From: Abbott, Nigel <Nigel.abbott@dmhstallard.com>
Sent: 28 August 2026 11:50:55 UTC+01:00
To: "Anna Tidey" <anna.tidey@midsussex.gov.uk>
Subject: RE: Environmental Health Officer comments for DM/26/1999 - Oakfield House, 35 Perrymount Road, Haywards Heath [DMHS-DMS.FID8218842]
Attachments: A26134-1 Mech GA rev 0.pdf, LU26002.00.82.SITE.G.pdf

Subject: DM/26/1999 Oakfield House

RXP25N9 Cooling mode

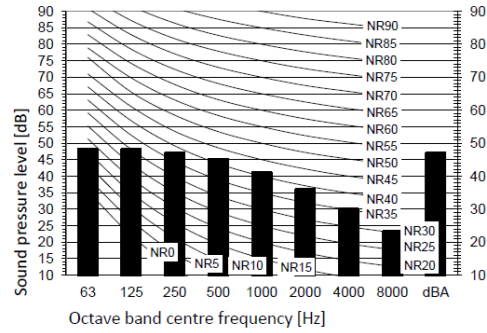
In addition Jane has requested clarification of the Air conditioning unit which is proposed, and the sound pressure level at a specified distance (or the sound power level).

It's not clear from the information submitted which model of AC will be installed, also I need the sound pressure level at a specified distance (or the sound power level) which isn't given in the data. The model mentioned, ARXP20-35N9 RXP20-35N9, doesn't correspond with models listed on the specification table for RXP-N9.

Below is the acoustic performance data for the proposed unit.

- The sound power levels of the equipment/plant to be installed or sound pressure levels at a specified distance, in decibels dB(A), (which can be obtained from the manufacturers specifications). **Applicant response: see data provided below**

Cooling

A	B
dBA	46

Heating

A	B
dBA	47
